Access Compliance Report

Public Rights-of-Way

(Curb Ramps)

Intersection ID: 10161	Main Street: E_35TH_ST	Cross Street: YADKIN_AV	Location: N
ADA ID: FCEDD1ECB482	Ramp Type: PerpDiag	Initial Pass/Fail: Fail	Overall Compliance: No
			Severity Score: 46.25

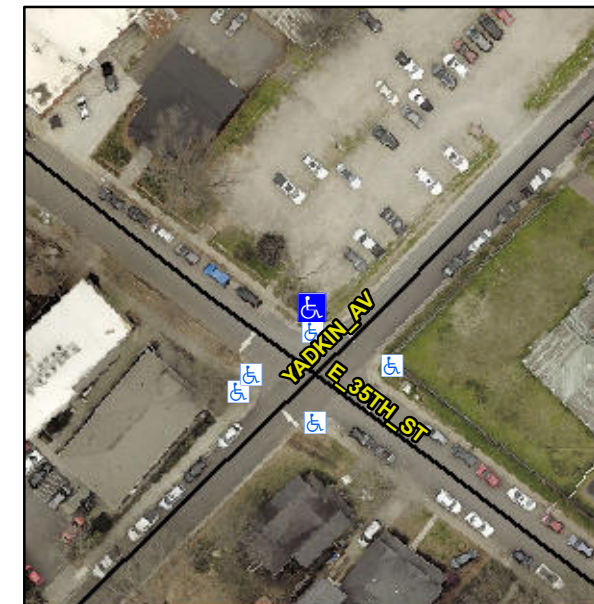
Not Found, R304.5.1, R304.2.2, R304.5.3

Compliance	Description	Data	Compliance	Description	Data
N/A	Ramp Length (in)	52.0	No	Ramp Slope (%)	9.7
No	Ramp Width (in)	47.0	No	Ramp XSlope (%)	8.3
N/A	Flare Type LT	N/A	N/A	Flare Type RT	N/A
N/A	Flare Slope LT (%)	N/A	N/A	Flare Slope RT (%)	N/A
N/A	Flare Traversable LT?	N/A	N/A	Flare Traversable RT?	N/A
N/A	Landing Length (in)	N/A	N/A	DWS Provided?	N/A
N/A	Landing Width (in)	N/A	N/A	DWS Contrast?	N/A
N/A	Landing Slope (%)	N/A	N/A	DWS Length (in)	N/A
N/A	Landing X Slope (%)	N/A	N/A	DWS Full Width?	N/A
N/A	Landing Curb? (Y/N)	N/A	N/A	DWS Offset (in)	N/A
N/A	Shared Landing?	N/A			
N/A	Gutter Ponding?	N/A	N/A	Gutter Slope (%)	N/A
N/A	Gutter Lip Ht (in)	N/A	N/A	Gutter X Slope (%)	N/A
N/A	Painted X Walk1?	No	N/A	Painted X Walk2?	No
	X Walk 1 Direction	To SW		X Walk 2 Direction	To SE
N/A	X Walk 1 Width (in)	N/A	N/A	X Walk 2 Width (in)	N/A
	X Walk 1 Slope (%)	2.5		X Walk 2 Slope (%)	0.2
	X Walk 1 X Slope (%)	0.8		X Walk 2 X Slope (%)	6.9

Remove & Replace Curb Ramp With Two New Directional Ramps or Equivalent.
